ECN/PCN No.: 3449

For Manufacturer																														
Product Description: GPS/Beidou/Glonass/Galileo/QZSS External Antenna		Abracon Part Number / Part Series: AEAGMK148060-S1575																												
Affected Revision: A		New Revision: B																												
Application		<input checked="" type="checkbox"/> Series <input type="checkbox"/> Part Number																												
Prior to Change: 1. N/A		<input type="checkbox"/> Safety <input checked="" type="checkbox"/> Non-Safety																												
After Change: 1. Gain and Axial Ratio values for specific frequencies 2. Radiation patterns for specific frequencies from table 3. Added return loss characteristic for 1.227 GHZ <div style="display: flex; justify-content: space-between;"> <div style="width: 45%;"> <p>4.0 Radiation Patterns</p>

Engineering/Process Change Notice

AEAGMK148060-S1575

RETURN - LOSS CHARACTERISTICS

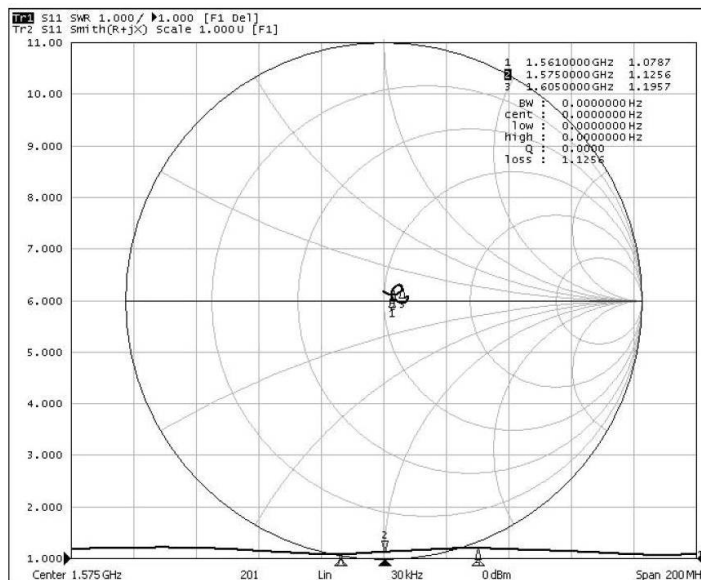
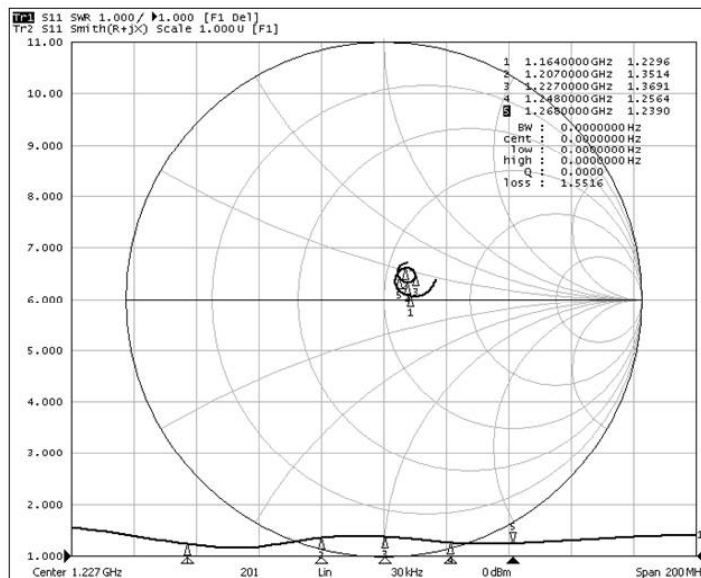
Change Plan	Effective Date: 08/05/2019	Additional Remarks: N/A	
Change Declaration: Added Radiation Pattern images for specific frequencies along with gain and axial ratio values for the specified frequencies, added return loss characteristic for 1.227 GHZ			
Issued Date: 7/30/2019	Issued By: Daniel Montoya	Issued Department: Engineering	
Approval: Syed Raza Engineering VP	Approval: Reuben Quintanilla Quality Manager	Approval: Ying Huang Purchasing Director	
For Abracon EOL only			
Last Time Buy (if applicable): N/A		Alternate Part Number / Part Series: N/A	
Additional Approval: N/A	Additional Approval: N/A	Additional Approval: N/A	
Customer Approval (If Applicable)			
Qualification Status: <input type="checkbox"/> Approved <input type="checkbox"/> Not accepted Note: It is considered approved if there is no feedback from customer 1 month after ECN/PCN is released			
Customer Part Number:		Customer Project:
